**BEFORE THE
PUBLIC SERVICE COMMISSION OF WISCONSIN**

**Application of Wisconsin Public Service Corporation
for a Certificate of Public Convenience and Necessity
for Construction of a Large Electric Generating Plant
with Associated Facilities, Known as Weston 4, at its
Existing Weston Generating Station Located in
Marathon County**

Docket No. 6690-CE-187

**Direct Testimony of
David A. Schlissel and Geoffrey L. Keith
Synapse Energy Economics, Inc.**

Figure SK-1: WPS Projected DSM Savings

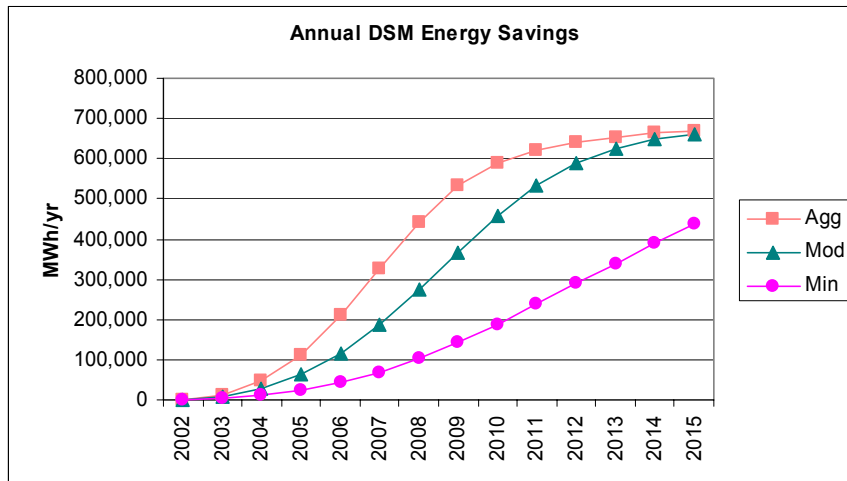
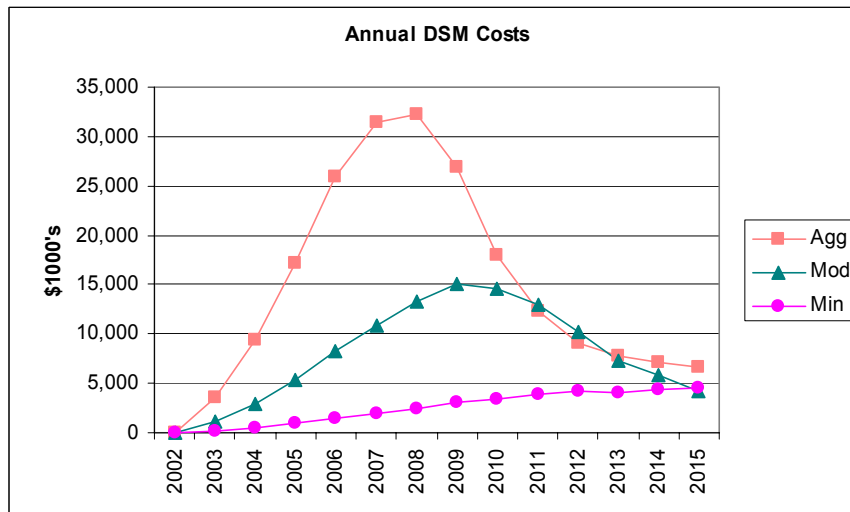
19 A. Yes. The DSM programs as used by WPS in its EGEAS analyses are oddly
20 designed. For example, as shown in Figures SK-1 and SK-2, the Moderate and the
21 Very Aggressive DSM programs produce nearly the same energy savings by the
22 final program year of 2015. However, the Very Aggressive program is much
23 more expensive.

24 This appears to be because WPS's Very Aggressive DSM program spends a lot of
25 money (apparently not very efficiently) in the early years and then declines
26 rapidly. A better designed program would increase DSM expenditures over time,
27 but at a more gradual rate, in order to achieve a larger, but more cost-effective,
28 level of energy savings.

Figure SK-3: Results of PSCW Staff EGEAS Scenarios

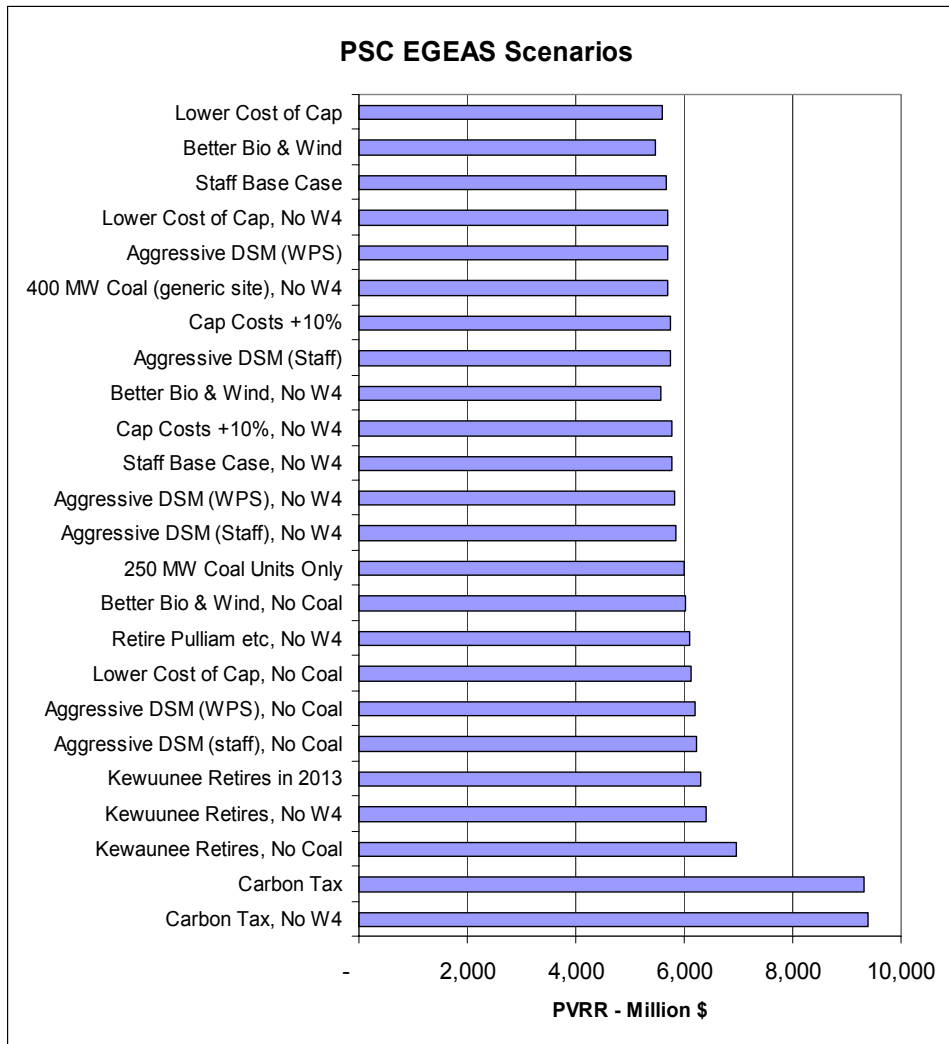
8 **A. Yes. This is shown in Figure SK-3 below.**

4 A. No. The results of the comparisons presented in Table SK-1 show that there are
5 credible scenarios in which plans without Weston 4 would have PVRR reasonably
6 close to the PVRR of PSCW Staff's optimal base case and the scenario in which
7 the cost of Weston 4 is ten percent higher than currently forecast. However, we
8 do not believe that the Commission should reject WPS's application for a CPCN
9 solely on the basis of these results or on the weaknesses we have found in WPS's
10 EGEAS modeling. Instead, we believe that the PSCW Staff should rerun its
11 EGEAS analyses reflecting the following assumptions:

Figure SK-4: WPS Fuel Mix Based on MWH Generation

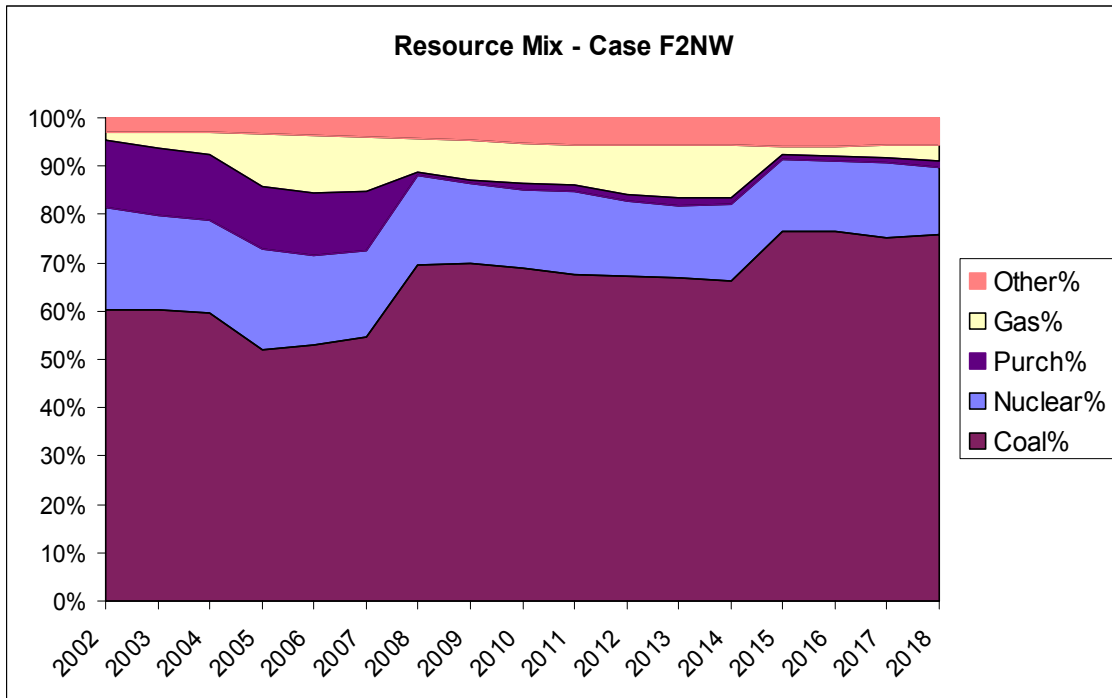
21 The effect of adding Weston 4 is even more pronounced if we consider the
22 percentage of the Company's total energy that would be generated by coal-fired
23 units. For example, as shown in Figure SK-4 below, under WPS Plan F2NW the
24 percentage of WPS's electricity that was generated at coal-fired facilities would
25 increase from approximately 63 percent in 2002 to about 70 percent in 2018.

5 A. This increasing reliance on electricity from coal-fired generating units leaves
6 WPS's ratepayers exposed to the substantial risk of CO₂ taxes or regulations or
7 coal industry events that could dramatically raise the price of the electricity from
8 these facilities. At the same time, air emissions can be expected to be
9 significantly higher than they would be under alternative plans that included
10 substantial amounts of DSM and wind capacity, as well as some smaller coal
11 and/or natural gas-fired generating units.
